To: T10 Technical Committee  
From: Rob Elliott, HP (elliott@hp.com)  
Date: 23 October 2006  
Subject: 05-381r6 SAS-2 Multiplexing

Figure 8 — State machines for expander devices [\[updated to include logical phys\]](#)

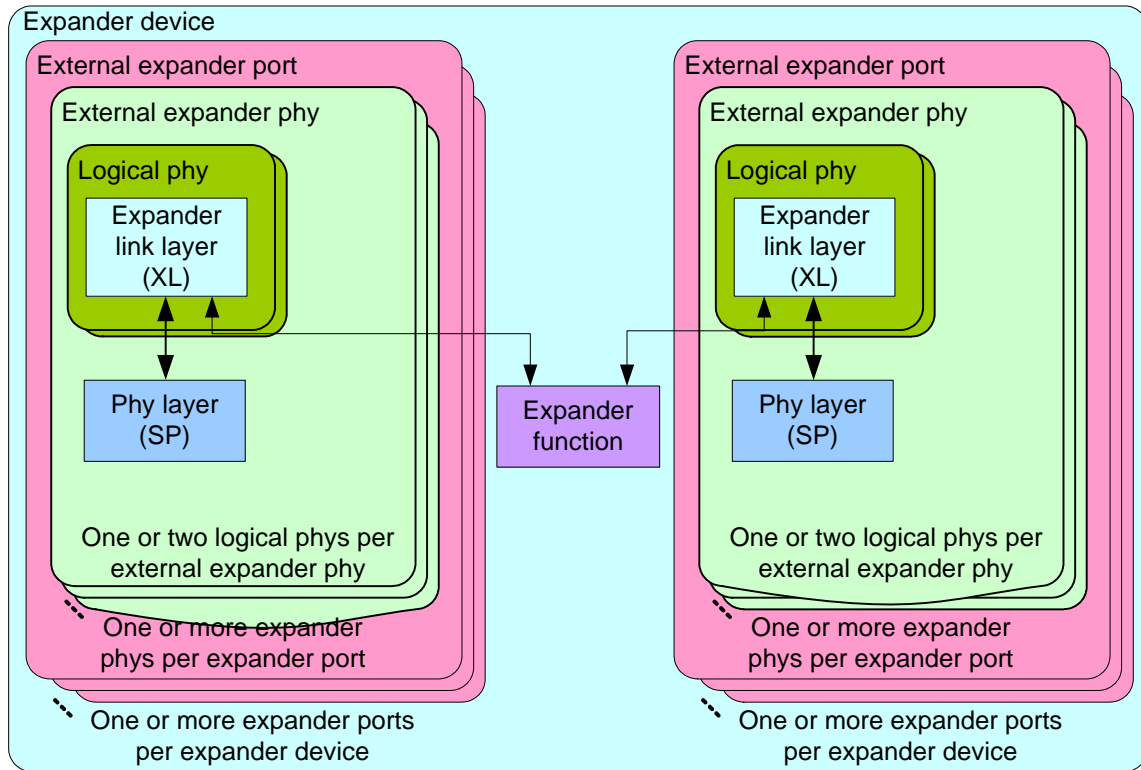
Editor's Note 2: Consider including SL\_IR in the previous figure alongside XL. It goes in the logical phy. It should probably be renamed SXL\_IR or L\_IR so the name doesn't imply it is only used by SAS phys.

Figure 11 — Receive data path in a SAS phy [\[updated\]](#)

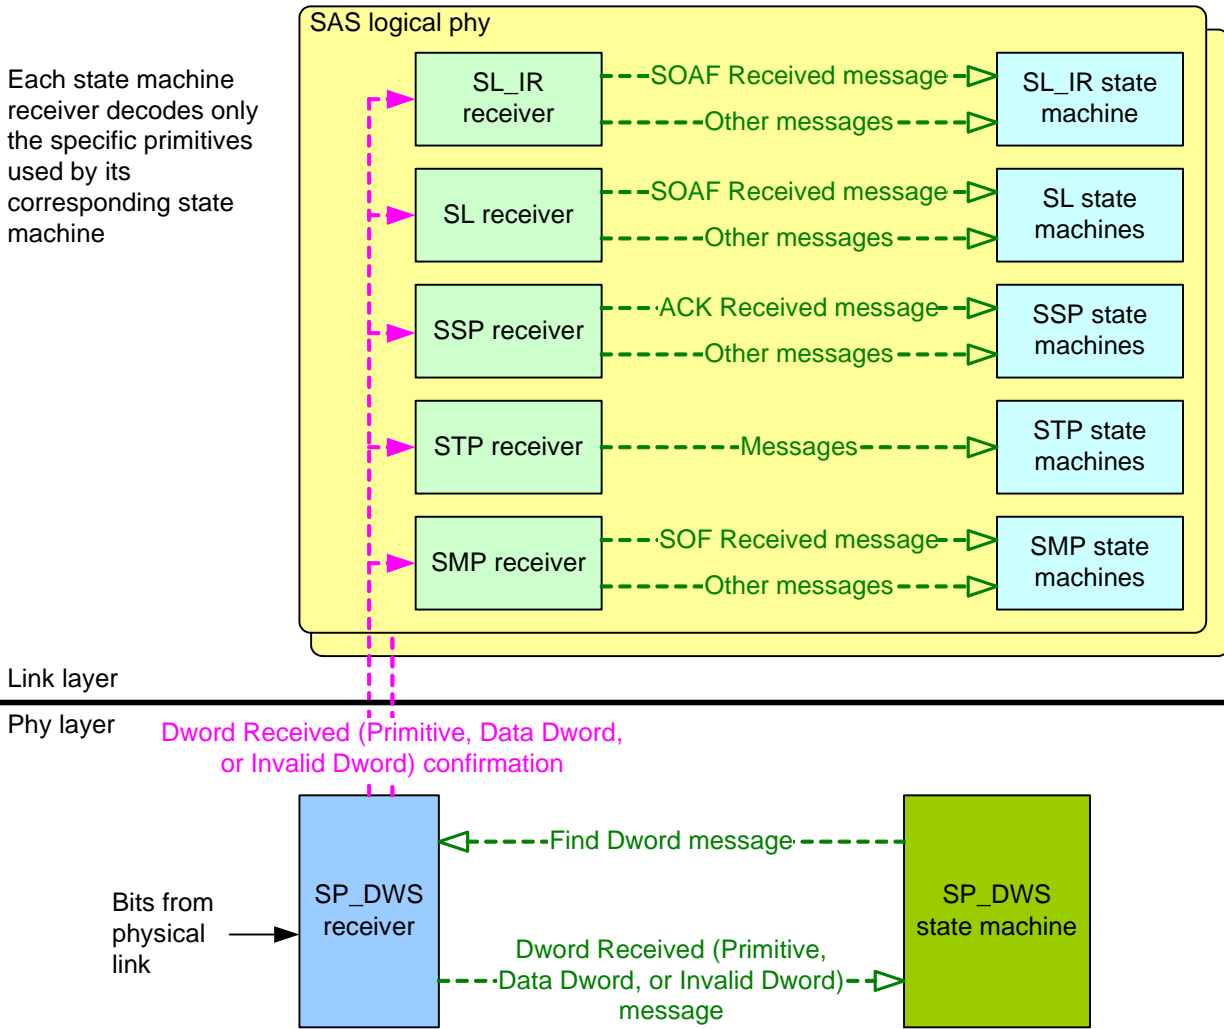
[If multiplexing is enabled, the SP\\_DWS receiver uses incoming MUX primitives to determine the logical link numbers and route the dwords to the appropriate link layer receivers.](#)
